TECHNICAL REVIEW AND ADVISORY PANEL (TRAP) MEETING

TECHNICAL REVIEW AND ADVISORY PANEL (TRAP) MEETING MINUTES

19-01 ISSUE FOR TECHNICAL REVIEW AND ADVISORY PANEL CONSIDERATION

Subject: Nitrogen-Reducing Media Lined Drainfields

41 Figure 1. INRB media layer system

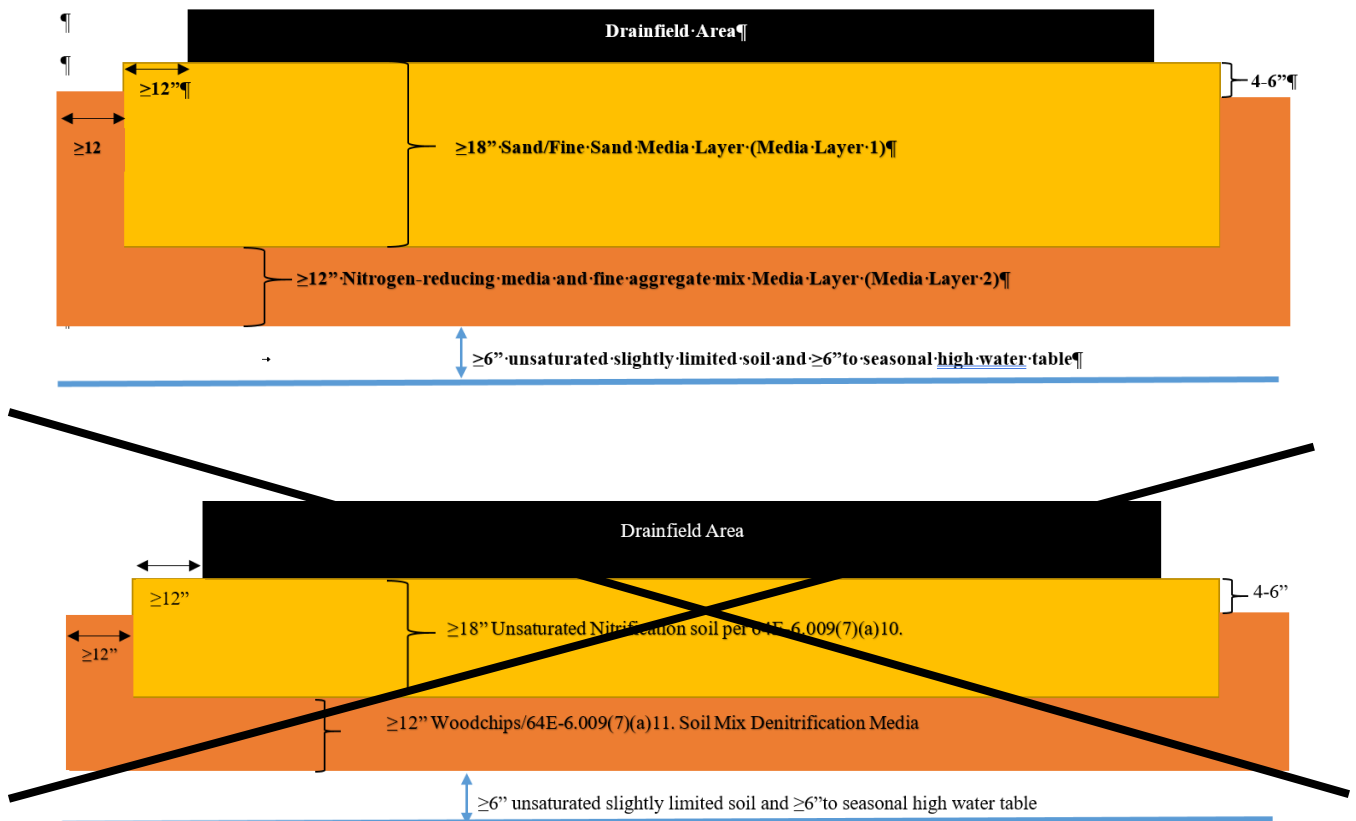
19 (a) ~~INRB Nitrogen-reducing media~~ layers shall be installed as follows:

20 1. This layer described in this subparagraph shall also be referred to as media layer 1. The
21 drainfield shall be installed centered over sand fill material that is at least 18 inches thick and
22 conforms to the textures and colors in subparagraph 10. below. Media layer 1 ~~and~~ shall extend
23 at least one foot beyond the perimeter of the drainfield. ~~The drainfield shall be centered above~~
24 ~~the sand fill area.~~

25 2. Below media layer 1 ~~the sand fill material layer required in subparagraph 1. above~~ there
26 shall be a nitrogen-reducing media and fine aggregate mix media layer, also referred to as

27 media layer 2, that is at least 12 inches thick and extends beneath the entire drainfield
 28 absorption surface and extends at least 24 inches beyond the perimeter of any portion of the
 29 drainfield absorption surface and any other effluent release point. ~~The Media layer 2~~ shall also
 30 extend upward along the boundary of media layer 1 ~~the sand-fill material~~ to a point four to six
 31 inches below the bottom of the drainfield. Media layer 1 ~~The drainfield~~ shall be centered above
 32 ~~the media layer 2~~. ~~The Media layer 2~~ shall conform with subparagraphs 8. and 11. below. ~~The~~
 33 ~~media layer shall not be installed when the observed water table is at or above the lowest depth~~
 34 ~~of media layer.~~

35 3. The bottom of the media layer 2 shall be at least 6 inches above the wet season water
 36 table.

182 Figure 2 INRB with Liner without underdrain

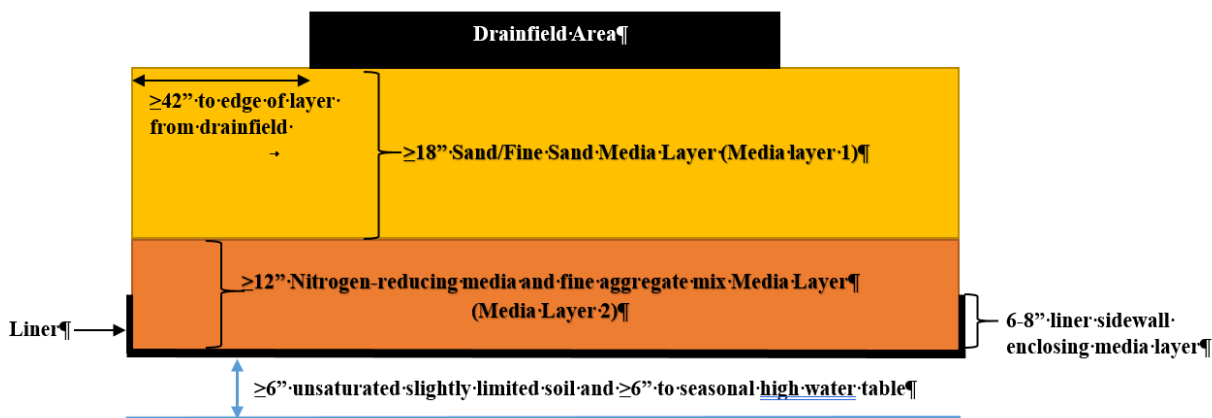
104 (b) INRB layers with Liner, no underdrain, shall be installed as in paragraph (a) above with
105 the following variations:

114 2. Media layer 2 shall be enclosed beneath and on the lower 6-8 inches of all sides by an
115 impermeable liner composed of polyvinyl chloride (PVC), high-density polyethylene (HDPE),
116 ethylene propylene diene methylene (EPDM) or other material having a thickness of at least 30
117 mils and being certified by the manufacturer for a minimum lifetime of 30 years buried in contact
118 with sewage.

119 3. No portion of the liner or media layer 2 shall be within 18 inches of the infiltrative surface

121 4. The lowest point of the liner or media layer shall be no less than 6 inches above the water
122 table at the wettest season of the year. There shall be at least 6 inches of unsaturated slightly
123 limited soil between the bottom of the liner and the seasonal high water table.

124 5. Media layers 1 and 2 shall extend beneath the entire drainfield absorption surface to a
125 point at least 3.5 feet beyond the perimeter of any portion of the drainfield absorption surface
126 and any other effluent release point. For repairs, the 3.5 feet dimension may be reduced
127 incrementally to not less than 1.0 feet if necessary to comply with a setback or if physical room
128 is unavailable. Maintaining the 3.5 feet dimension shall have a protection factor of 5 in
129 determining the relative priority of competing factors in the application of rule 64E-6.015 Table
130 V. No part of the liner shall be placed within 18 inches of the pump or treatment tank.

217 Figure 3 – INRB with Liner with underdrain

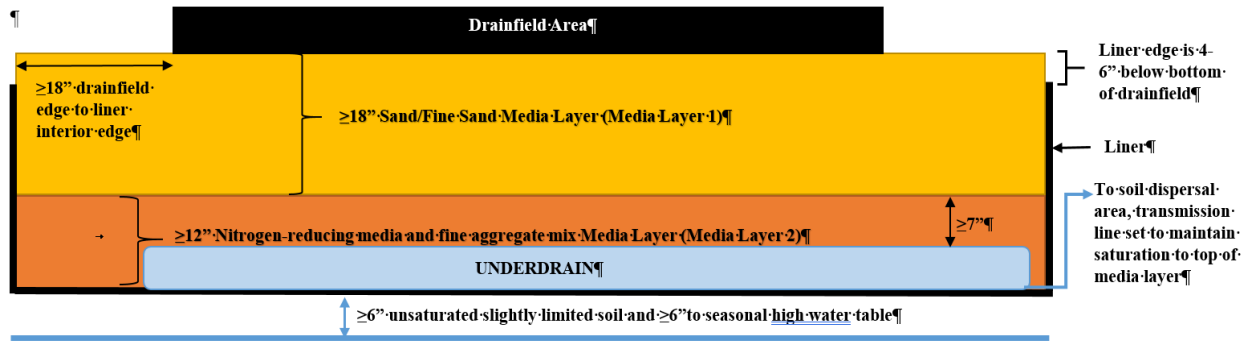
183 (c) INRB layers with Liner with underdrain, shall be installed as in paragraph (a) above with
184 the following variations:

185 1. The drainfield shall be installed and centered over media layer 1 which conforms to the
186 textures and colors in subparagraph (a)10. Media layer 1 must extend at least 18 inches past
187 the perimeter of the drainfield.

188 2. Below media layer 1, media layer 2 shall be installed and must extend at least 18 inches
189 past the perimeter of the drainfield. Media layer 2 shall conform with subparagraphs (a)8. and
190 (a)11., above.

191 3. An impermeable liner meeting the construction standards of subparagraph (b)3., above,

192 shall be installed below media layer 2. The liner's interior surface must extend to a point at least
193 18 inches past the perimeter of the drainfield, at which point the liner shall be directed upwards
194 toward the ground surface maintaining contact with media layers 1 and 2, stopping at a point
195 four to six inches below the level of the bottom of the drainfield. No portion of the media layer
196 shall be less than 18 inches below the infiltrative surface of the drainfield. Media layer 2 with
197 liner shall extend beneath the entire drainfield absorption surface and extend at least 18 inches
198 beyond the perimeter of any portion of the drainfield absorption surface and any other effluent
199 release point. No part of the liner shall be placed within 18 inches of the pump or treatment tank.

200 4. An underdrain shall be installed on top of and in contact with the interior surface of the
201 bottom of the liner within the media layer, and shall disperse to a separately sized, located and
202 installed drainfield. The underdrain shall be designed to maximize effluent movement through
203 media layer 2 into the underdrain. The transmission line from the underdrain to the separate
204 drainfield shall be set to maintain saturation to the top of the media layer. In order to maintain
205 distribution as high as possible above the seasonal high water table and to maintain the most
206 shallow depth to finished grade the transmission line must not have a slope exceeding 1/8 per
207 foot when distributing the effluent to the separate drainfield.

213 6. The minimum thickness of media layer 2 as measured between the top of the underdrain
214 and the top of the media shall be 7 inches.
